**NAME OF WORK: Supplying, installation, testing and commissioning of Package Type Out Door Electrical Sub- Station including allied civil work and External Electrical Installations for BSL-3 Building in NCR-Biotech Science Cluster at Faridabad (Haryana)**

**Tender No.: RCB/OoC/NIT-01/20-21/PACKAGE ESS**

**CORRIGENDUUM- III Dated 30 th JULY,2020**

**REGARDING CLARIFICATION OF QUERIES OF BIDDERS (PRE BID MEETING DATED 21.07.2020 AT 15.00 hrs.)**

SLD

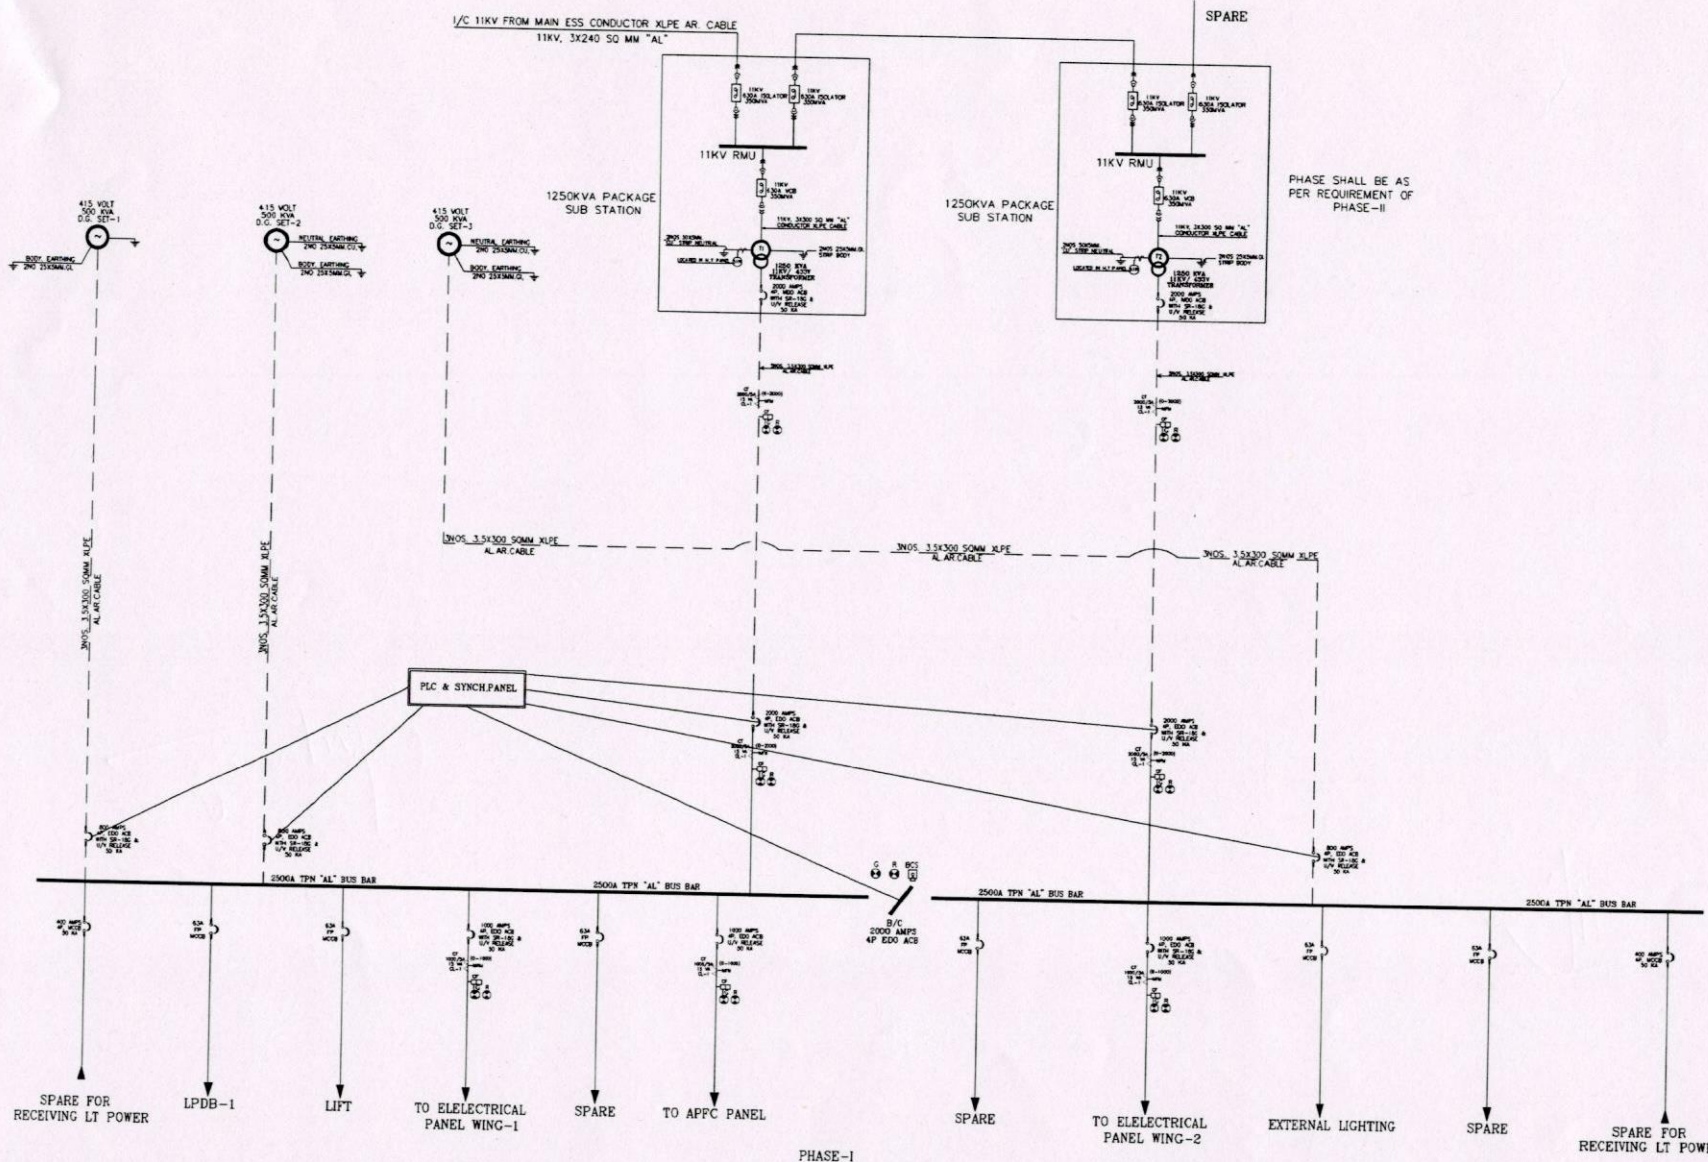
Sr. No.	Query / Observations from the intending bidders	Clarification/Modification by RCB
1	Kindly Provide the SLD as it is not clear in Tender documents on an urgent basis.	Scanned copy of revised SLD now uploaded on tender E-Wizard .
2	Kindly also consider the make of Sudhir, Essenar, C&S for Transformer and CSS.	No change in the make/brand already mentioned in the NIT
3	Kindly Also consider the make of Main LT Panel of Advance Panel and Switch gear, Risha Control Engineers, Adlec, C&S Ambit, LS Power Control Pvt. LTD or channel Partner of ABB, Siemens, Schneider & L&T.	Make of - (i) Advance panel & Switch gear and (ii) Adlec has been included in addition to that already mentioned in the NIT
4	Kindly Confirm that the DG Synchronizing Panel in our scope if it is Please Provide the complete specification and details of synchronizing Process.	The SITC for the synchronizing panel is already included in the scope of the work. The operation of DG sets shall be monitored and controlled by a PLC-based logic panel for auto change-over, auto synchronizing, and auto load-management. The sequence of starting and stopping of DG sets will be governed by the PLC panel as per the load requirement of BSL 3. Lab building. Provision for running of all the three DG at a time is to be made by the agency.

20	In NIT SLD CSS is shown with 3 Nos VCB. It needs checking. In general, CSS shall have 1 No 11KV VCB with 2 Nos 11KV Isolators.	The sealed 3-way RMU shall have 1 no. VCB and 2 nos. Isolators. The revised SLD enclosed for further references.
